Hams Garments Ltd (extension)

South Vangnahati, Chapilapara, Sreepur
(24.194313N, 90.452568E)

11th January, 2017

Floor beam detail from provided structural drawings

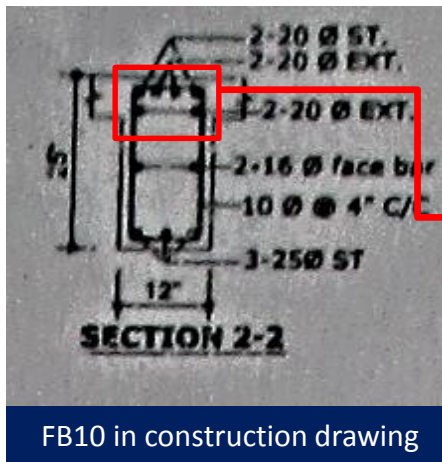
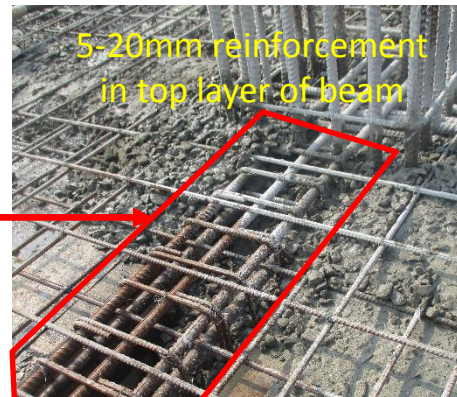
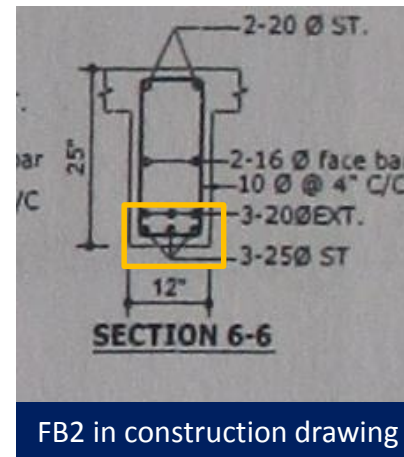
During inspection, roof floor concrete pouring was going on and all rebar's were placed. Discrepancies' was found in rebar placement of beams and construction drawings. 5-20mm dia rebar was found instead of 6-20 mm dia rebar in FB1 & FB10. More over 6-20mm dia rebar was found instead of 3-25mm & 3-20mm in bottom of Fb2 which indicate that the structural design has not been followed properly for construction.

Item No.	Observation	Recommended Action Plan	Recommended Timeline
1	Discrepancy between drawings and as-built condition	Factory engineer to investigate the whole building and review the design for missing reinforcement of beam and all other existing condition.	6-weeks
2	Discrepancy between drawings and as-built condition	Factory engineer to investigate the whole building and review the design considering the rotated columns, missing reinforcement of beam and all other existing condition	6-weeks
3	Discrepancy between drawings and as-built condition	Produce as-built drawing reflecting the as-constructed condition as a part of DEA.	6-weeks
4	Discrepancy between drawings and as-built condition	Carry out remedial work if required.	6-months
5	Sheds appeared to be non engineered	Factory engineer to check the lateral stability of two sheds against heavy wind load.	6-weeks
6	Sheds appeared to be non engineered	Factory engineer review the connection adequacy check of the both sheds.	6-weeks

Typical slab layout

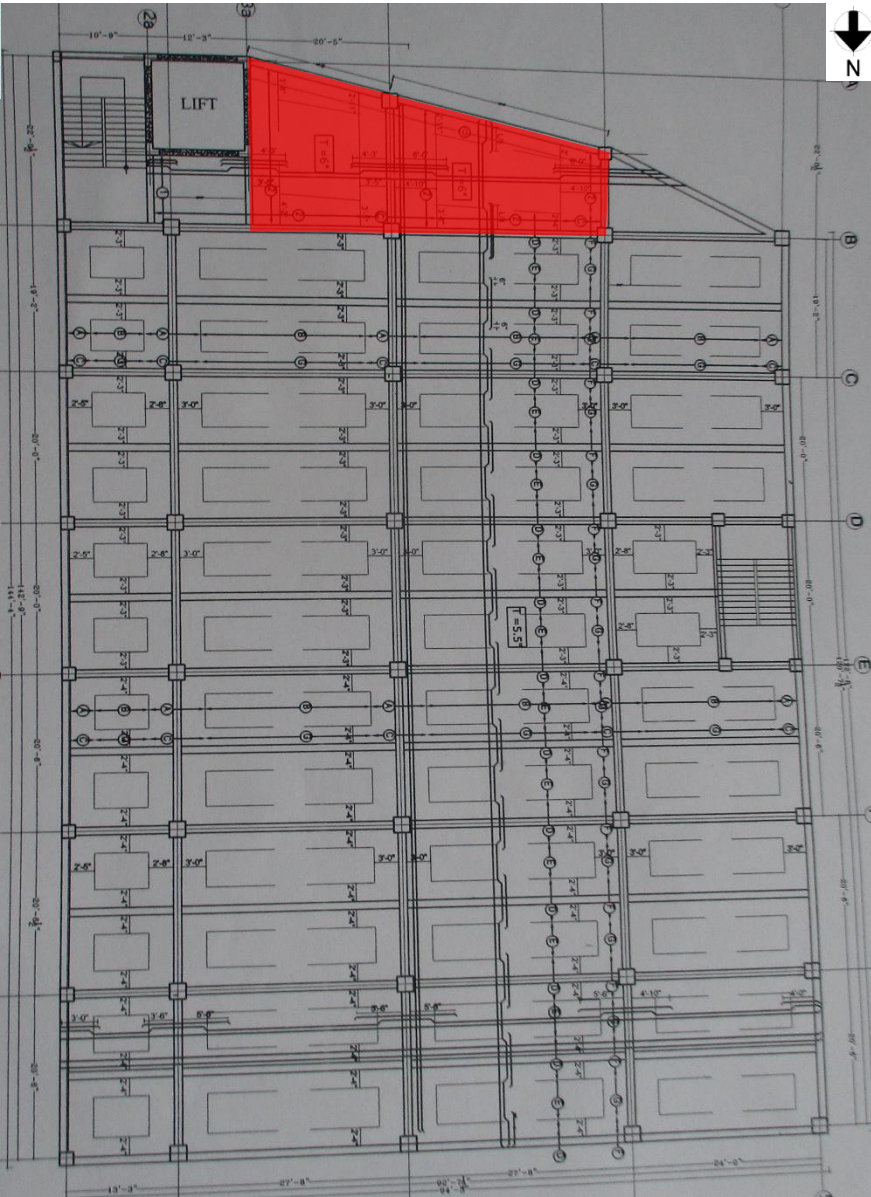
According to the working drawings slab thickness of the highlighted area is mentioned 150mm and 140mm in other portion. Construction work was ongoing at the time of inspection. Slab thickness was found more than 150mm.

Floor layout of 3rd floor

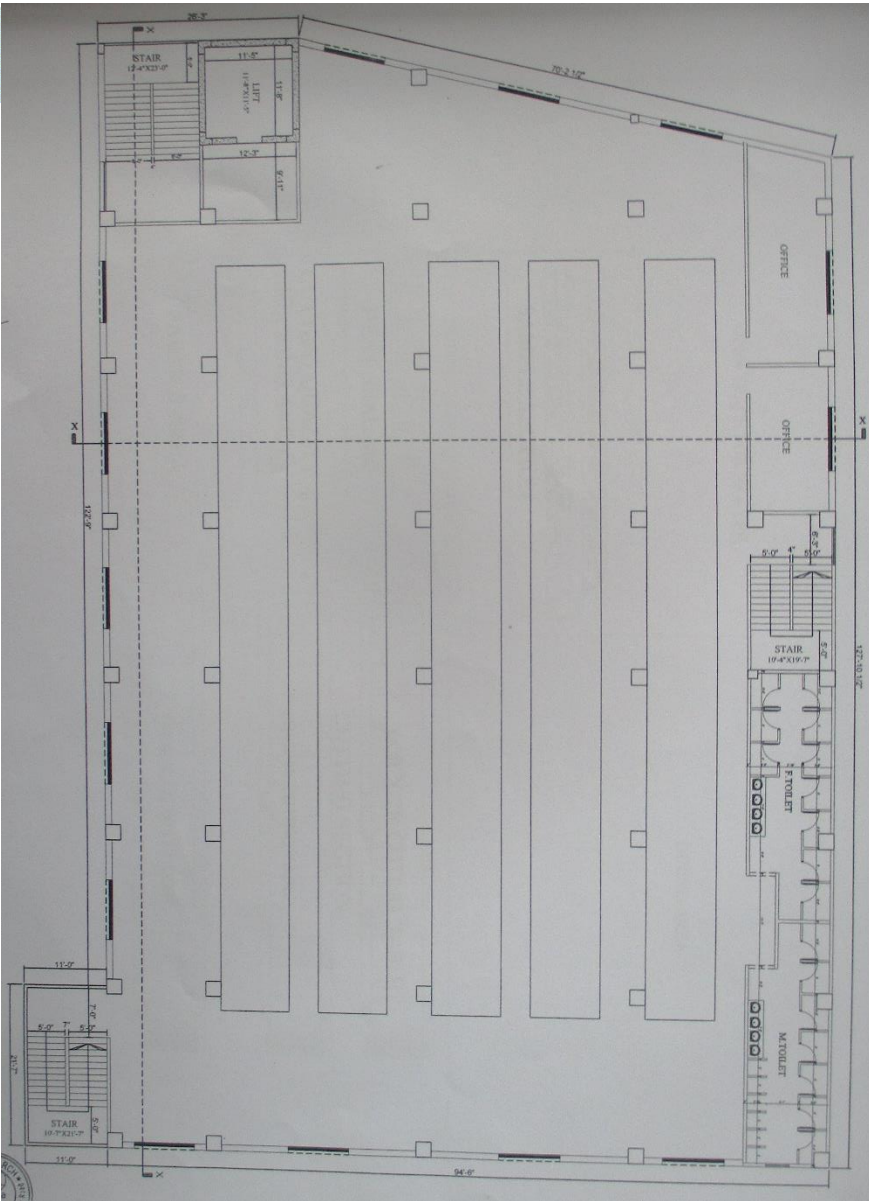
In floor plan the peripheral walls are shown as 125mm but 250mm thick wall was being constructed at the time of inspection as a result additional load should be considered for column capacity check

Typical grid dimensions measured on site from Gr floor to top floor

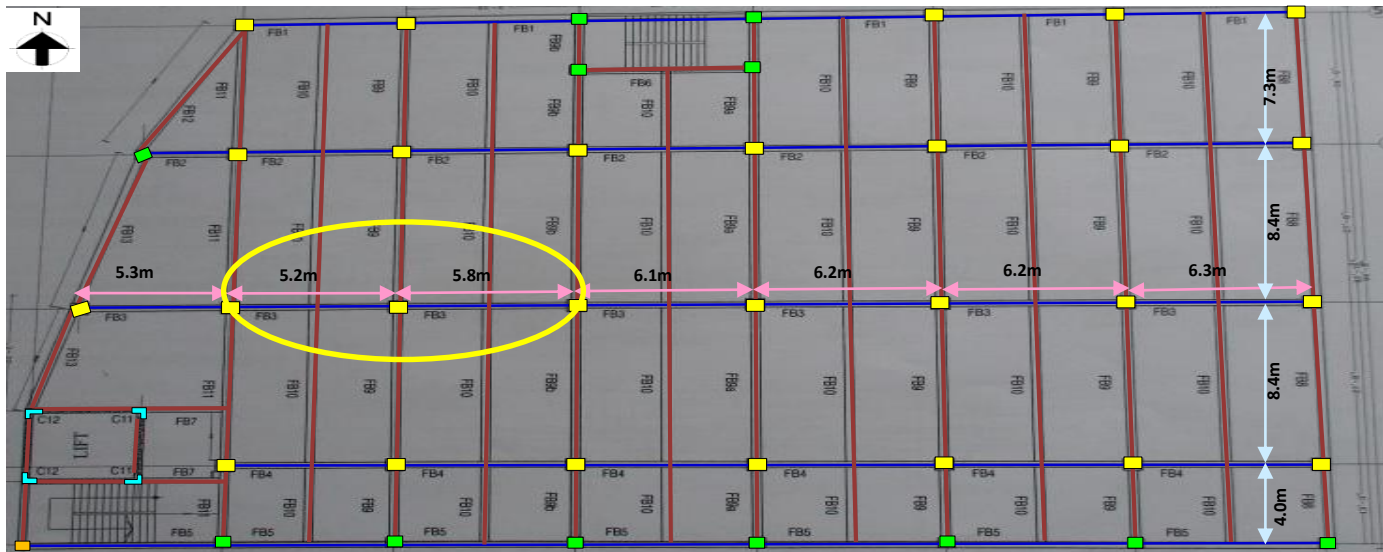
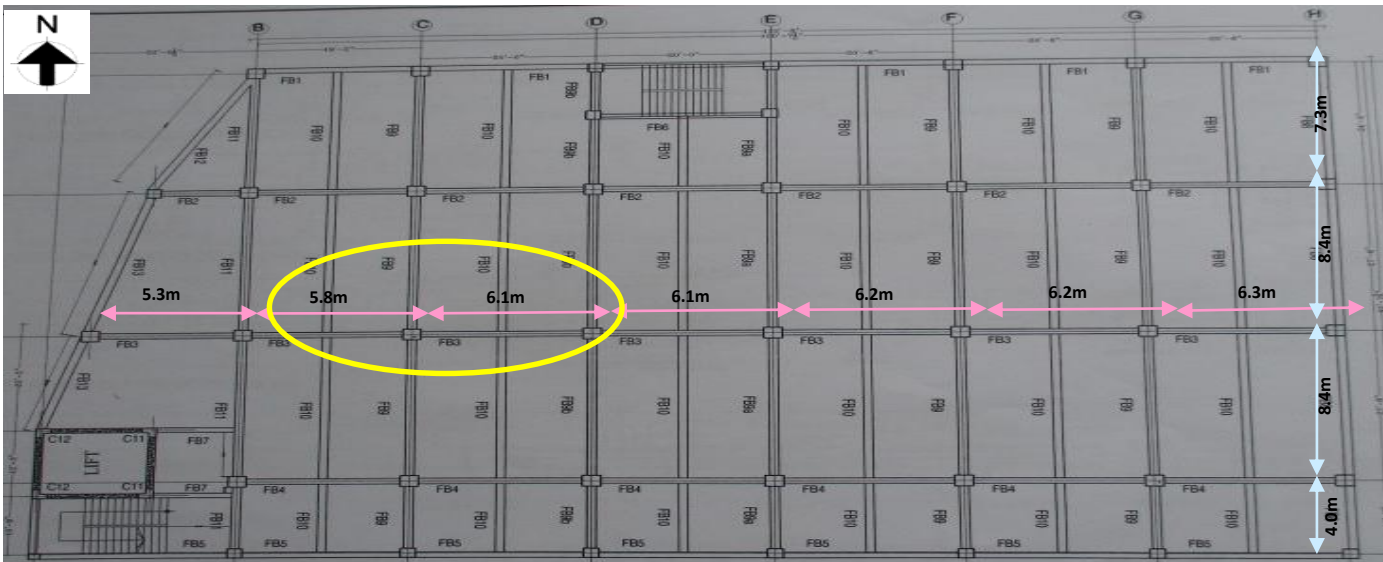
During inspection, column centre to centre distance was found around 0.9m less than provided drawing along 'X' direction

Shed-1

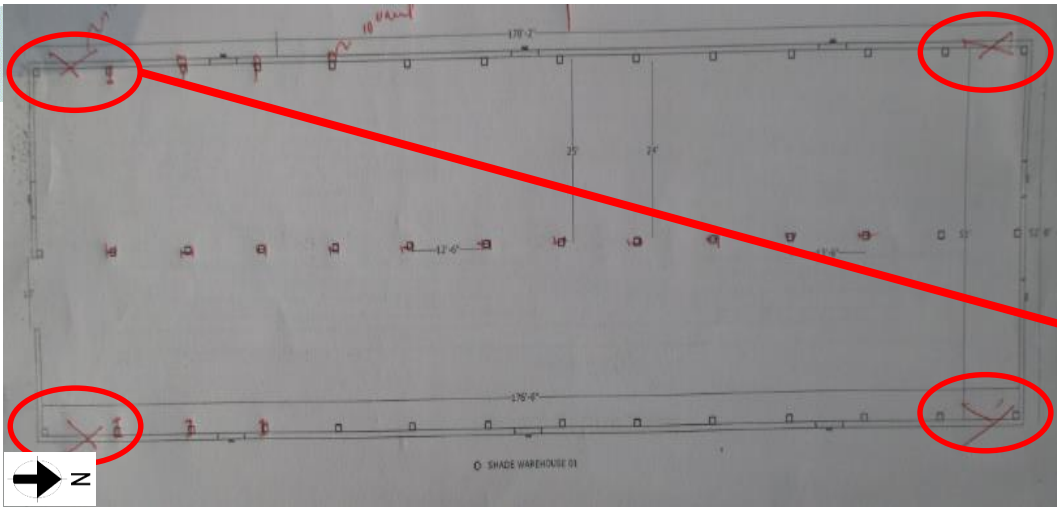
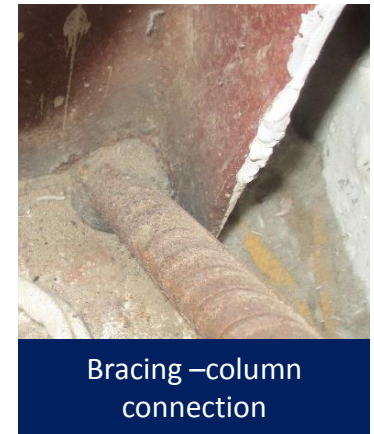
Sheds appeared to be non engineered

Connection in column-rafter joint and bracing-column joint appeared to be inadequate. Lateral stability in the long direction is provided by vertical bracing in the two end bay (red circle in the layout) which is appeared to be inadequate. Moreover, no horizontal bracing was observed in roof. Factory engineer has to check the lateral stability and adequacy of the connections.

7	Sheds appeared to be non engineered	Implement remedial work if required	6-months
8	Insufficient documents of two sheds	Factory engineer to produce as built documentation (both structural and architectural drawing) of two sheds.	6-weeks

Column layout of shed-1

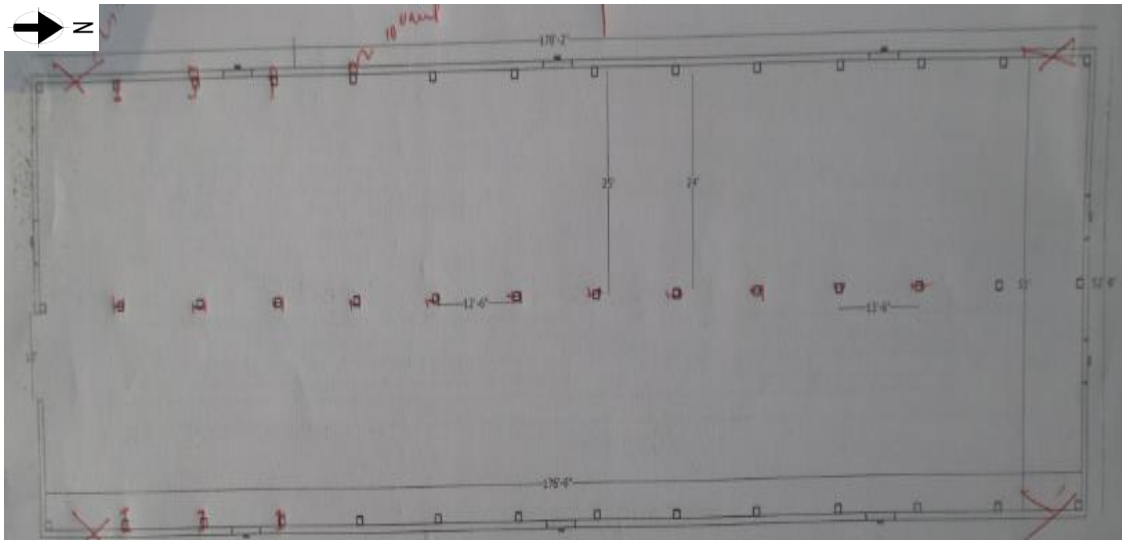
Insufficient documents of two sheds

At the time of inspection only typical column layout and architectural drawings were made available but no structural drawings were available for both sheds. Factory engineer has to produce as-built structural drawings for both sheds.
